## TRUCK, SURVEILLANCE RECONNAISSANCE VEHICLE (SRV-SF), LIGHTWEIGHT, FFR, W/WINCH, MC2, LAND ROVER 110, 4X4, ISUZU DIESEL ENGINE

### FITTING INSTRUCTIONS FOR UPGRADED WIRING LOOM TO ARB CKMA12 AIR COMPRESSOR

## MODIFICATION INSTRUCTION

**Figure 1 CKMA12 Air Compressor Wiring Diagram**

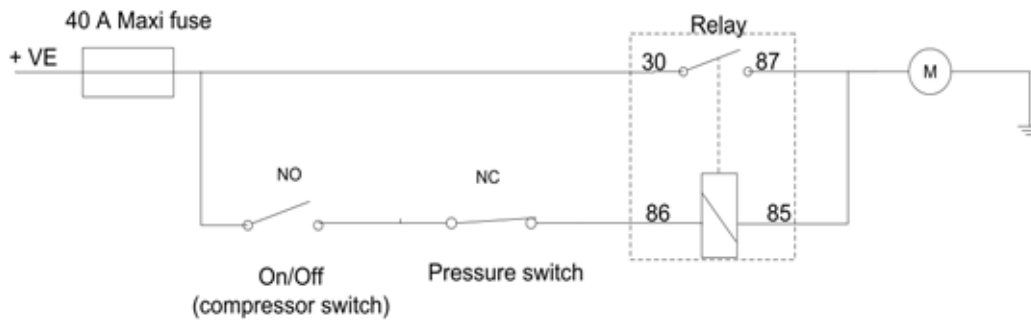
1. This instruction details the installation of an upgraded higher current capacity wiring loom for the 12 V air compressor (ARB CKMA12). The upgraded wiring loom is constructed from 3 mm and 5 mm core diameter wire replacing an incorrectly produced wiring of 3 mm and 3 mm core diameter wire. This Modification is only required for vehicles modified to fit the new ARB CKMA12 compressor carried out under EMEI Vehicle G 177-8 with only number 40 defaced on the modification plate. Vehicles modified under EMEI Vehicle G 177-8 with both numbers 40 and 33 defaced on the modification plate already have this upgraded wiring loom installed.

11. **Drawings Required.** A CKMA12 air compressor wiring diagram is shown in Figure 1.

Figure 7 Fuse Holder Position

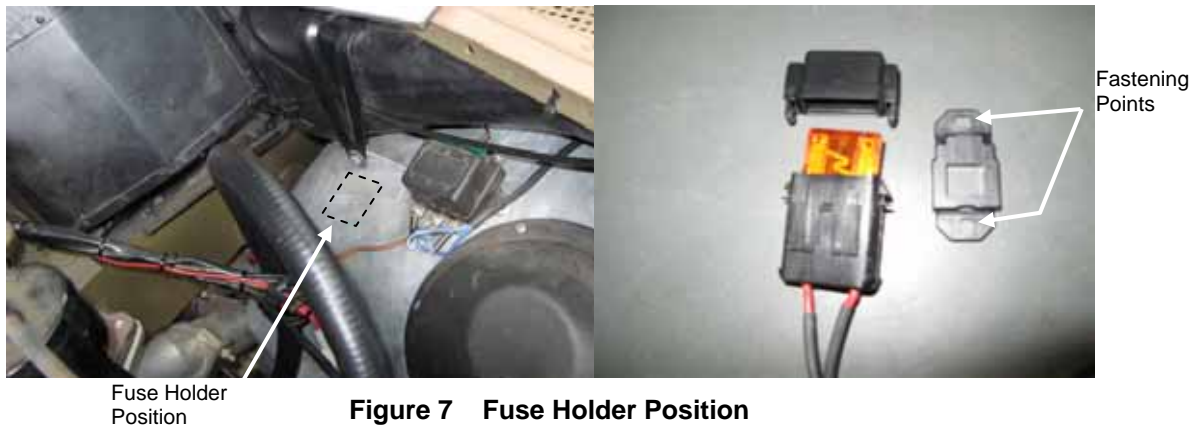
- c. **Fuse Holder.** Remove the 40-Amp Maxi fuse holder from the passenger side wheel well shown in Figure 7.

**Figure 9 Compressor Electrical Connections**

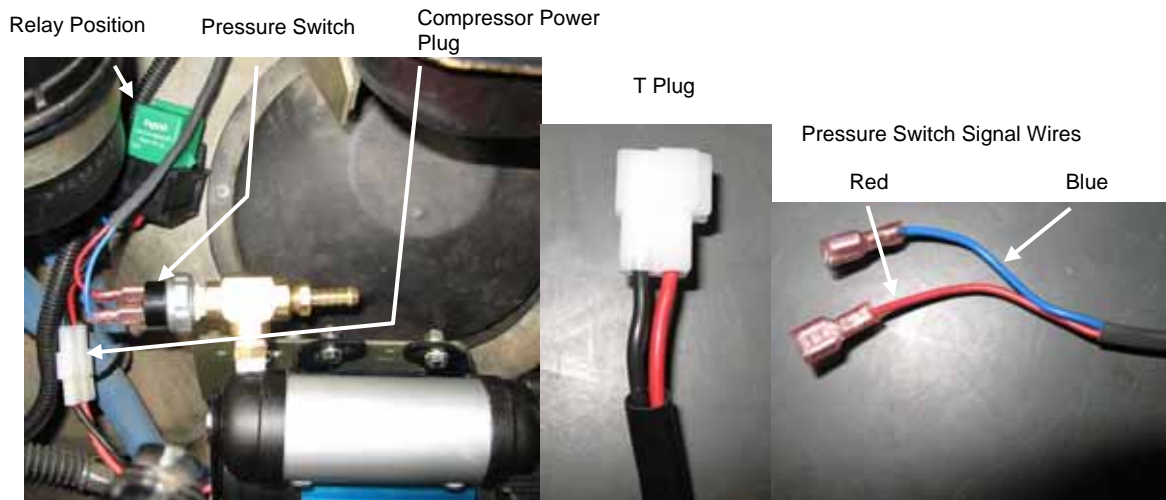
- e. **Relay.** Remove the relay from the driver's side wheel well as shown in Figure 9.

- f. **T Plug.** Detach the T plug (male) from the compressor and the red & blue signal wires with quick connects from the pressure switch as shown in Figure 9.
- g. **Compressor Dash Switch.** Disconnect the On/Off signal wires (red and purple/white) with quick connects (Figure 10) from the dash switch and remove from the firewall driver's side grommet (Figure 8). The On/Off signal wires are routed underneath the cross bar as shown in Figure 11.

**Figure 14 Fuse Holder Position**

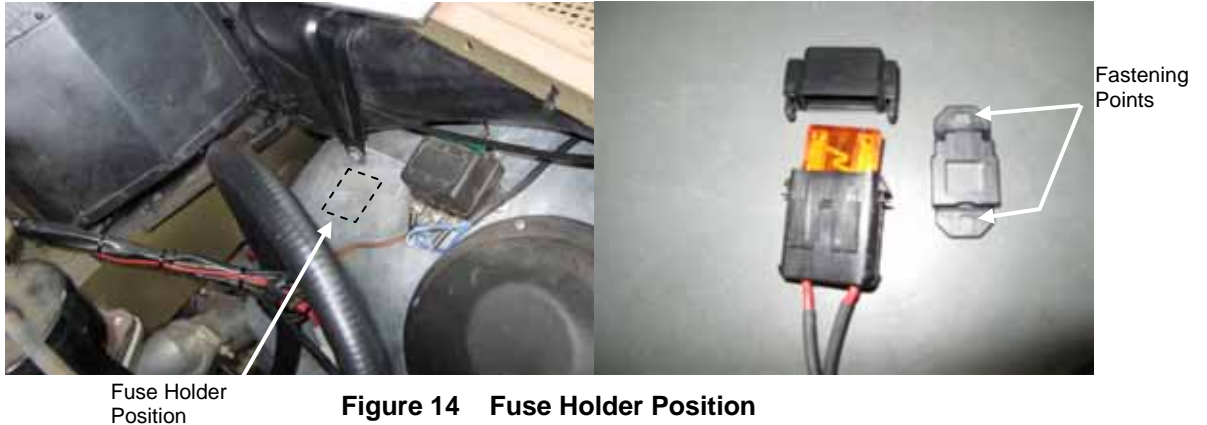
- c. **Fuse Holder.** Install the fuse holder as follows:
  - (1) Attach the fuse holder with M6 x 15 mm bolts with a flat washer either side of the wheel well and spring washer on the nut side (the nut will be on the outside of the vehicle).
  - (2) Secure the 40-Amp Maxi fuse holder to the passenger side wheel well.

**Figure 16 Compressor Electrical Connections**

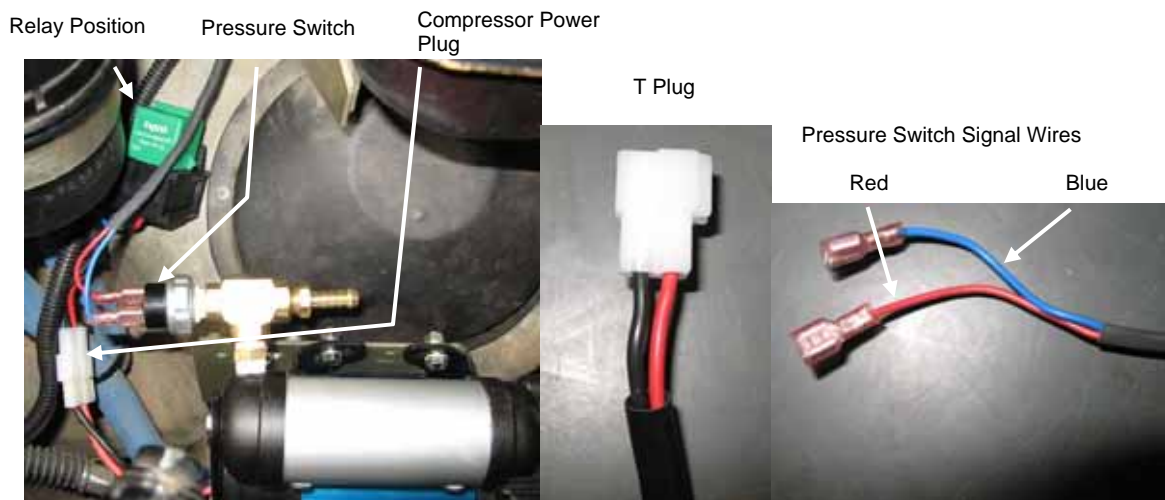
- (1) Attach and secure the relay with an M6 x 15 mm bolt with a flat washer either side of the wheel well and a spring washer on the nut side (the nut will be on the outside of the vehicle) as shown in Figure 16.

- (2) Attach the T plug (male) to the compressor and the red & blue signal wires with quick connects to the pressure switch, as shown in Figure 16 (the red and blue signal wires can go on either connection on the pressure switch).
- f. **Compressor Dash Switch.** Route the On/Off signal wires (red and purple/white) with quick connects (Figure 17), through the firewall using the driver's side grommet (Figure 15). Ensure that the On/Off signal wires are routed underneath the cross bar as shown in Figure 18.
